ACCESS REPORT

PROJECT: PLC – Secondary Innovation Precinct (SIP) and Campus Commons
PROJECT NO: GDL240387.1
PREPARED FOR: Pymble Ladies College
REVISION: C
DATE: 27/05/2025

6.0 APPENDIX B – PLAN MARKUPS (SIP BUILDING).

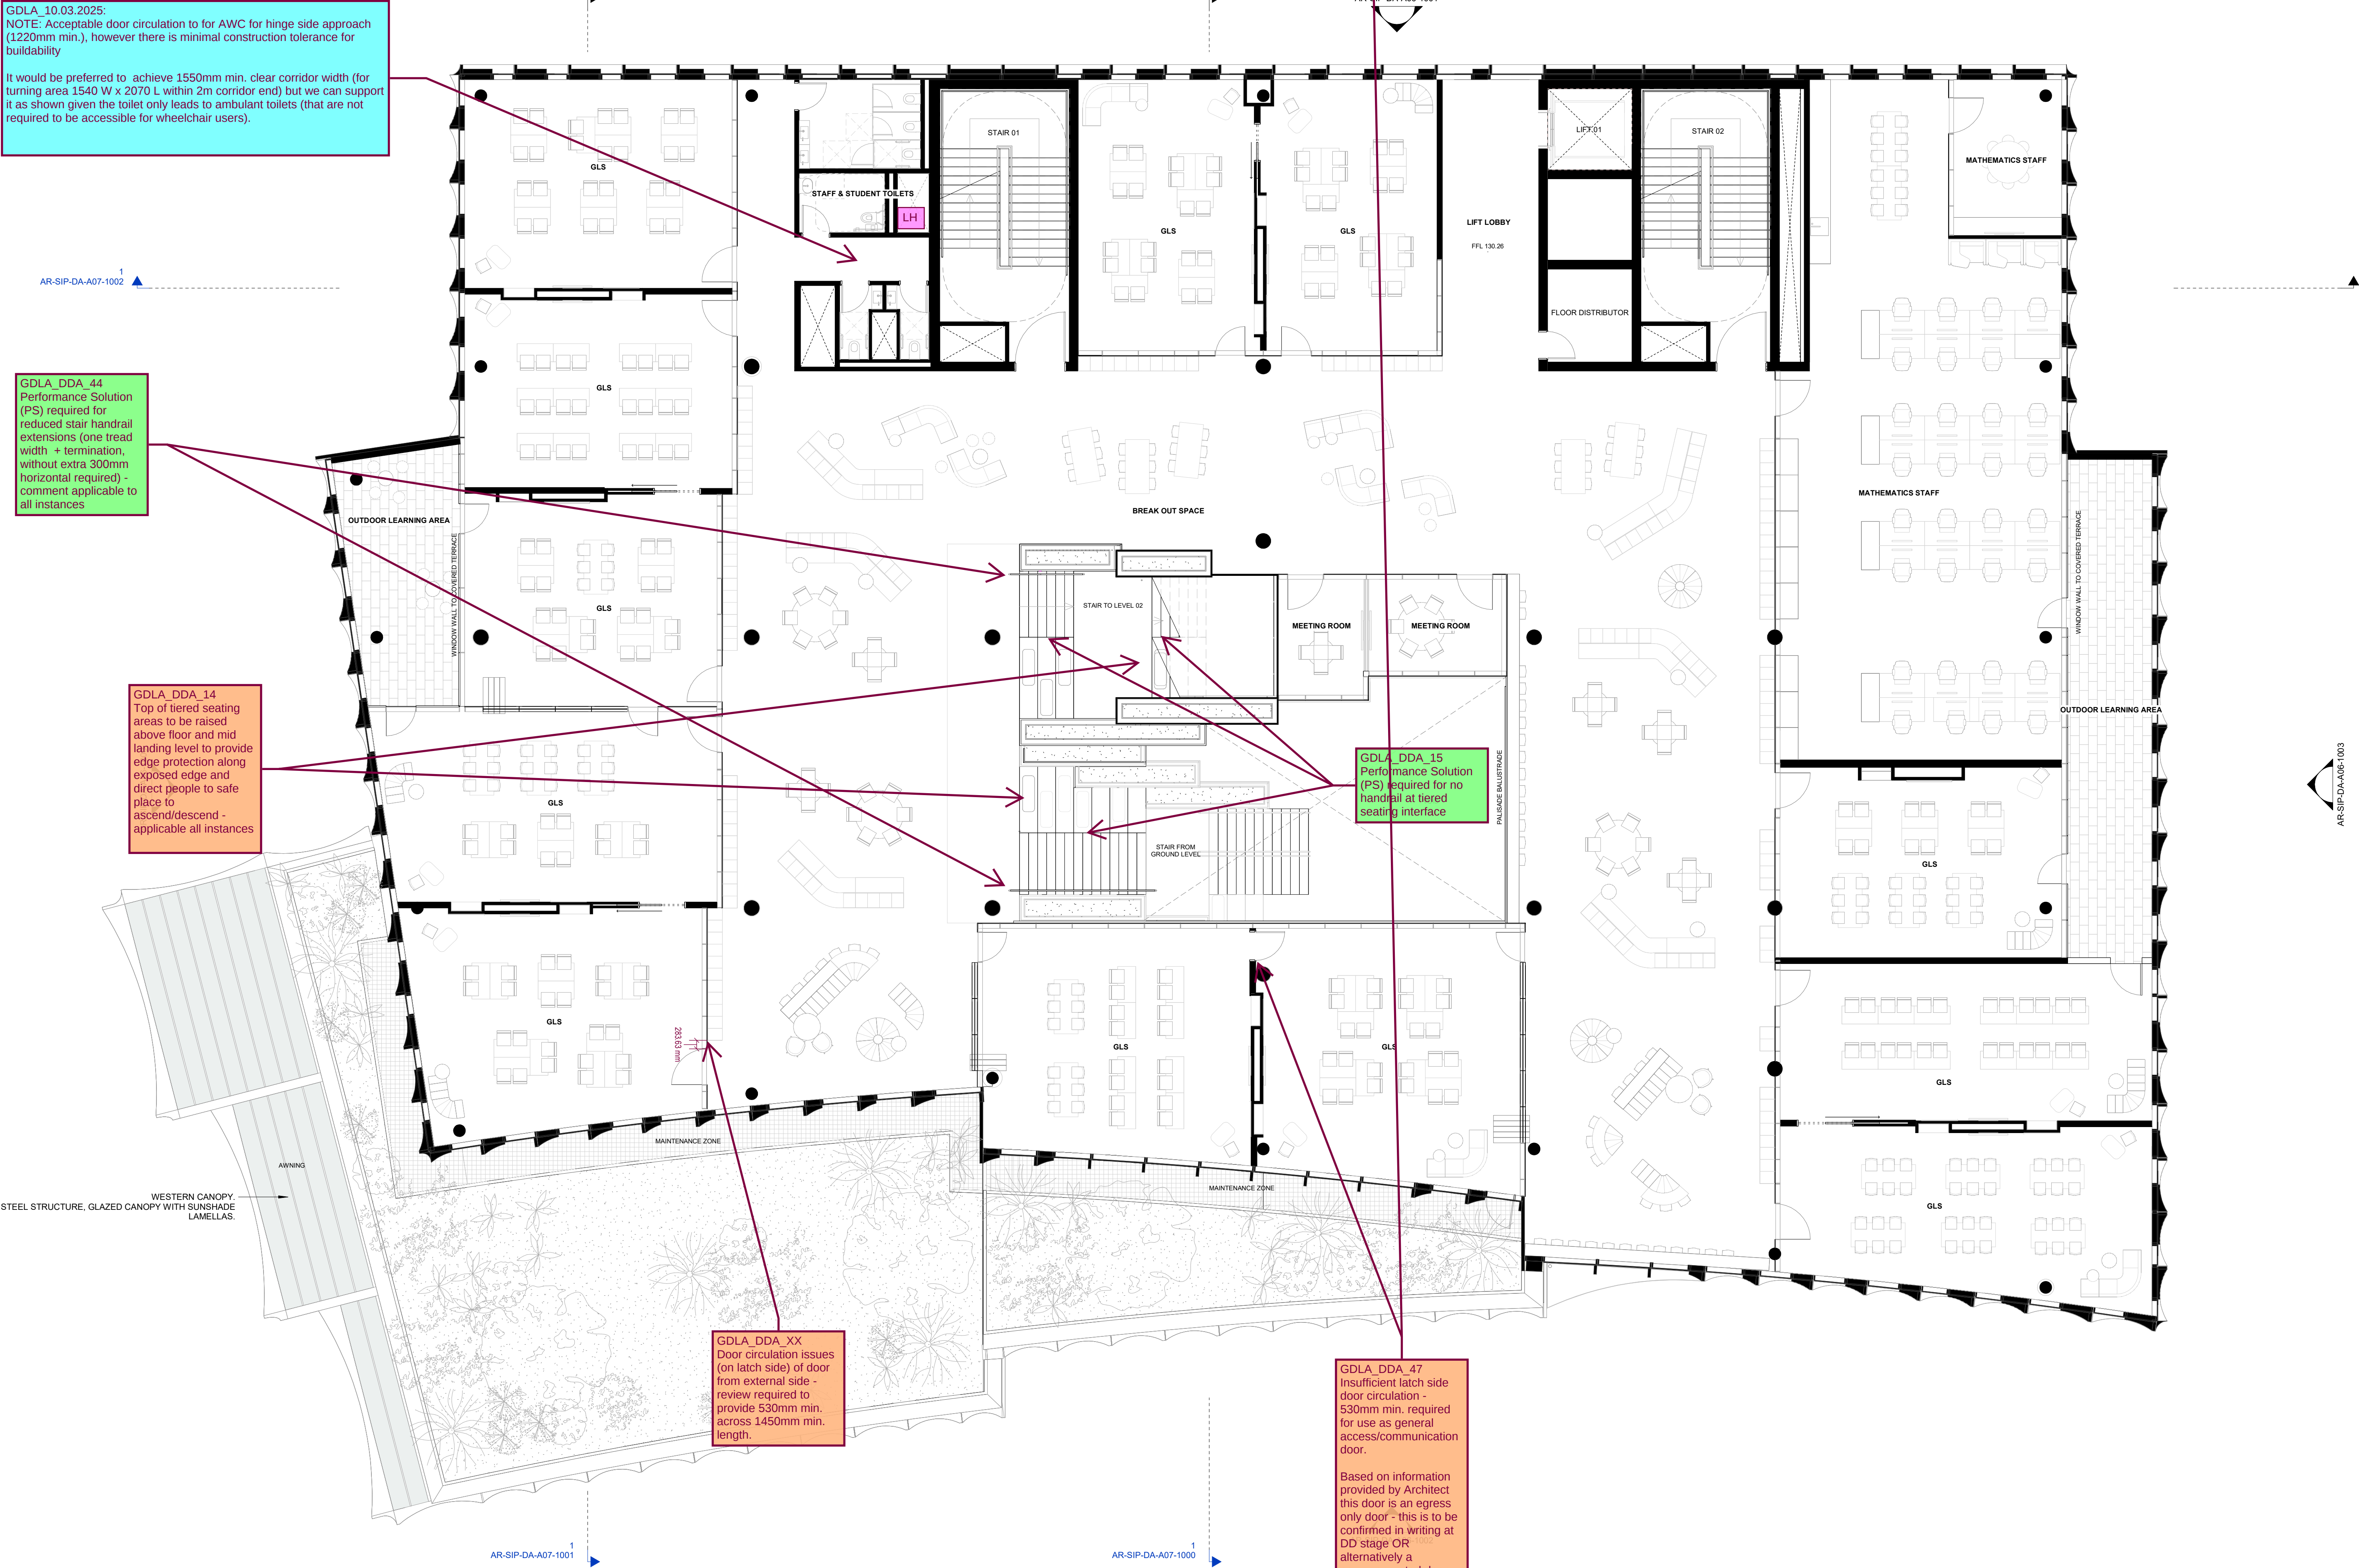
GDLA_DDA_44
Performance Solution (PS) required for reduced stair handrail extensions (one tread width + termination, without extra 300mm horizontal required) - comment applicable to all instances

GDLA_DDA_14
Top of tiered seating areas to be raised above floor and mid landing level to provide edge protection along exposed edge and direct people to safe place to ascend/descend - applicable all instances

GDLA_DDA_XX
Door circulation issues (on latch side) of door from external side - review required to provide 530mm min. across 1450mm min. length.

GDLA_DDA_44
Performance Solution (PS) required for reduced stair handrail extensions (one tread width + termination, without extra 300mm horizontal required) - comment applicable to all instances

GDLA_DDA_51
Handrail not permitted as shown. Provide continuous along flight perpendicular to treads

GDLA_DDA_15
Performance Solution (PS) required for no stair handrail at tiered seating interface - comment applicable to all instances

GDLA_DDA_45
TGSIs (600-800mm) required at top and base of each stair flight - comment applicable to all instances

GDLA_21.03.2025
Provide off-set tread at base of each stair flight (or increased size landing length so handrail can extend one tread width past base riser and clear of min. egress width/route) to ensure continuous consistent height handrail can be achieved to meet BCA and AS1428.1:2009 Clause 12 requirements

GDLA_DDA_59
provide at least 1000mm min. clear width paths of travel - common issue

GDLA_DDA_45
TGSIs (600-800mm) required at top and base of each stair flight - comment applicable to all instances

GDLA_DDA_15
Performance Solution (PS) required for no stair handrail at tiered seating interface - comment applicable to all instances
